Technical Service Bulletin: tsb100892

Released Date: 29-Jan-2013

New Intake and Exhaust Valves

**Old (left) and New (right) Intake and Exhaust Valve**

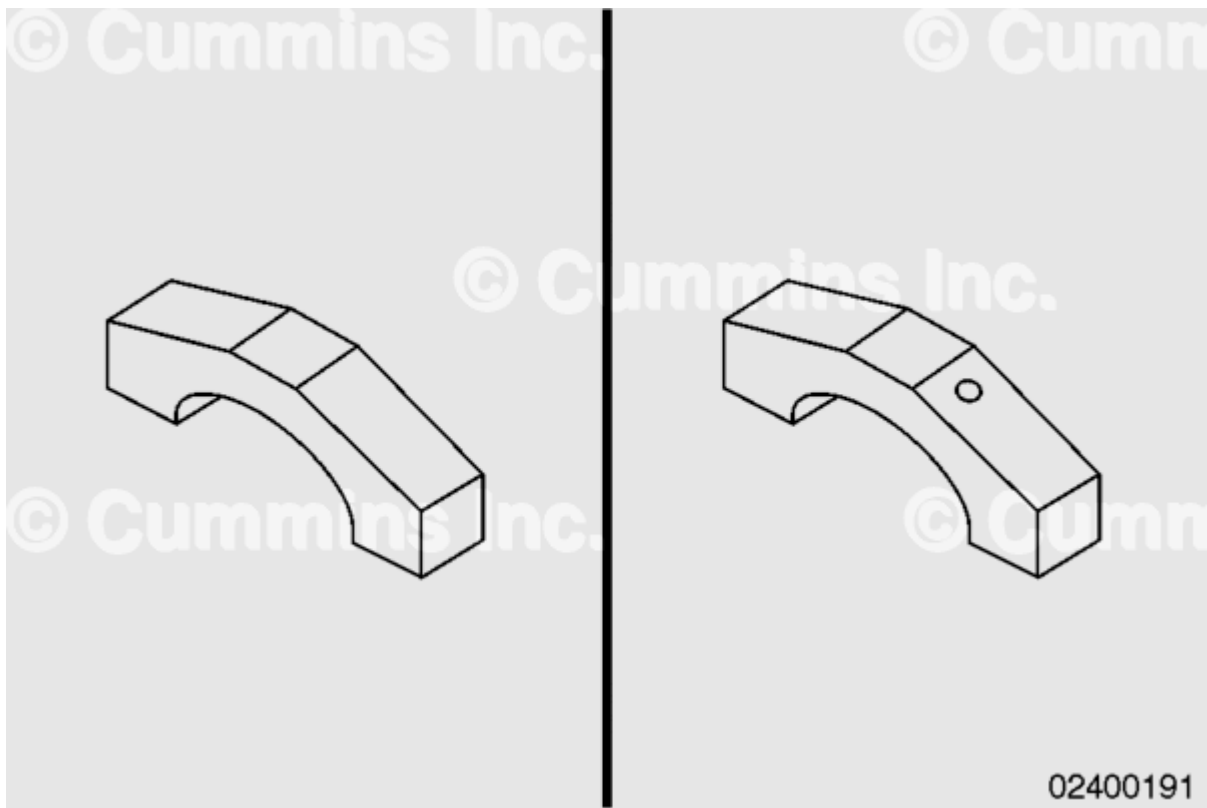
This document announces the release of new intake and exhaust valves for use on all QSK45, all QSK60 (including natural gas), and QSK19 engines (other than QSK19 MCRS). The new valves have a constant stem diameter to the end of the valve stem tip to improve robustness.

1. Thicker valve tip on the new valve
2. Collet groove.

Old (left) and New (right) Crosshead

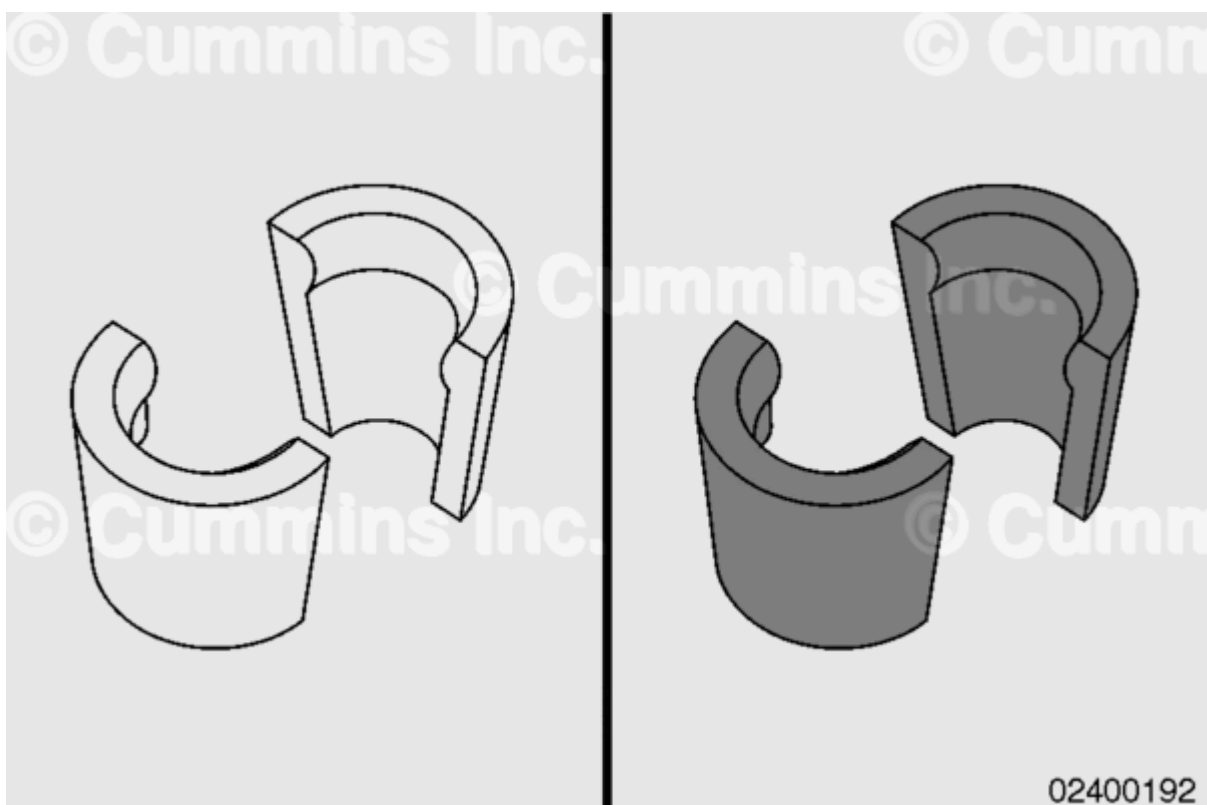
Note : The new crosshead **must only** be used with the new increased diameter valve stem tip. Do **not** install the new crosshead to the old style thinner valve stem tip valves. Engine damage can possibly occur.

1. Circle stamped on new crosshead.

Old (left) and New (right) Collets

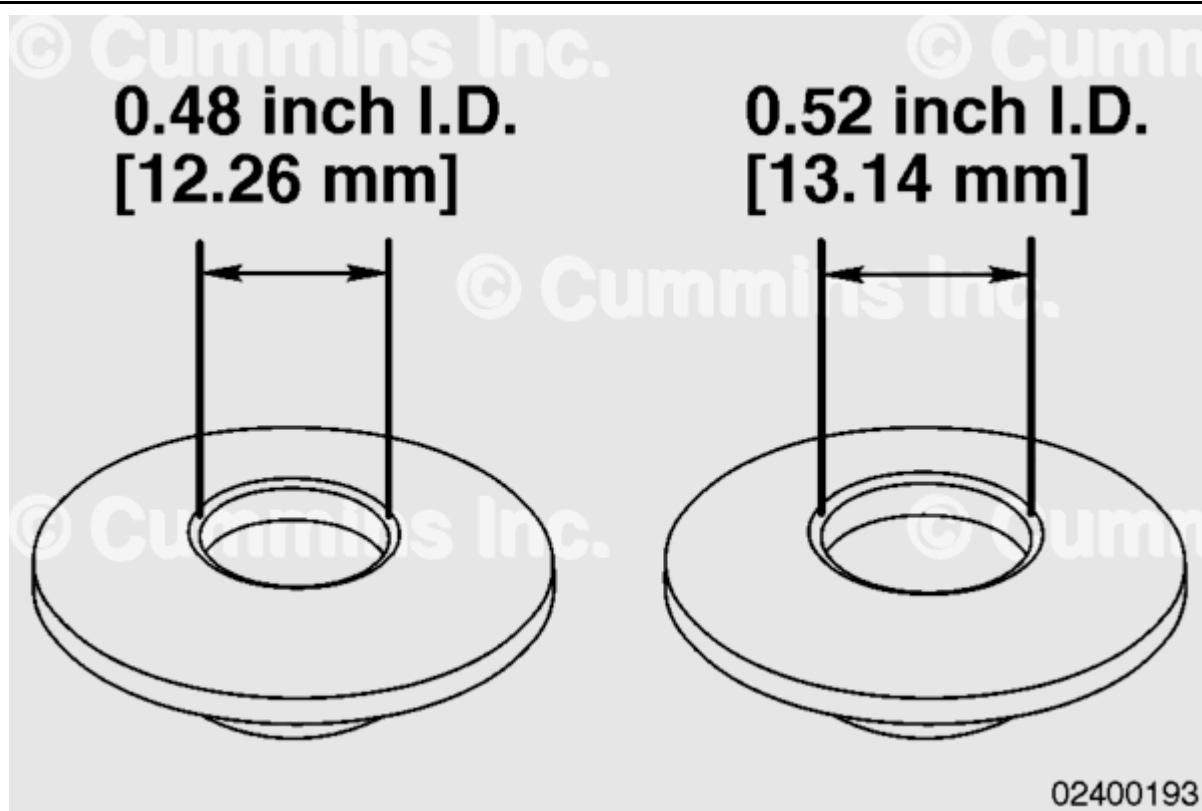
Note : New collets are copper in color.

Old (left) and New (right) Retainers

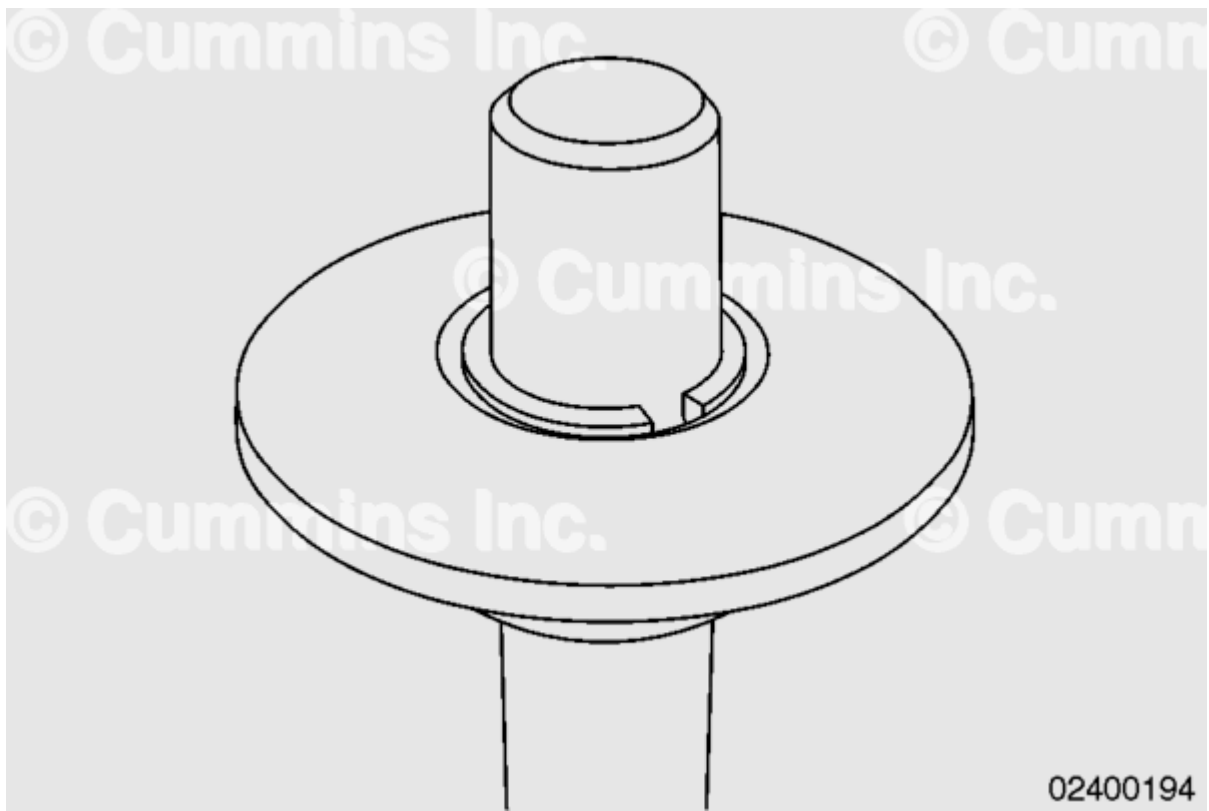
Note : The new retainers have a larger internal profile. If an old retainer is used, the new collets will not sit flush to the top of the retainer.

Measure the inside diameter at a distance of 2.3 mm [0.09 in] down from the top of the retainer.

Old retainer inside diameter at 2.3 mm [0.09 in] down from top: 12.26 mm [0.48 in]

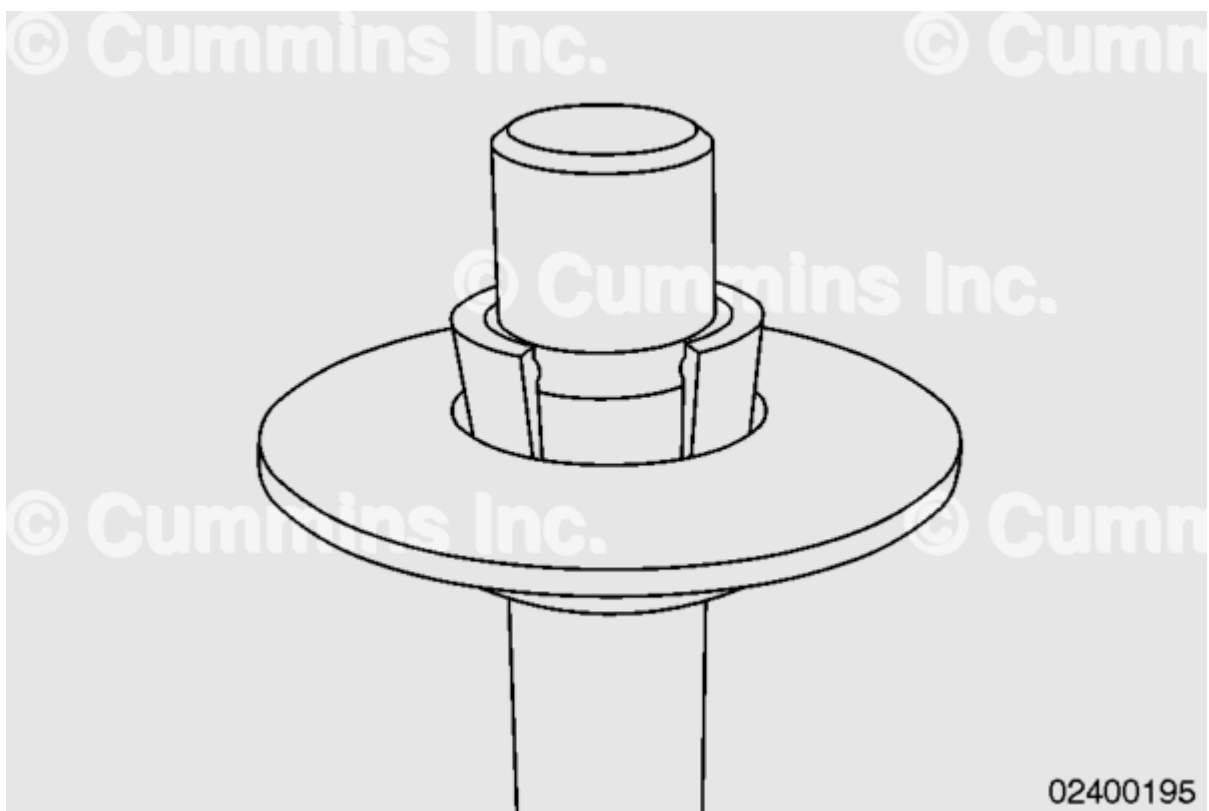
New retainer inside diameter at 2.3 mm [0.09 in] down from top: 13.14 mm [0.52 in]
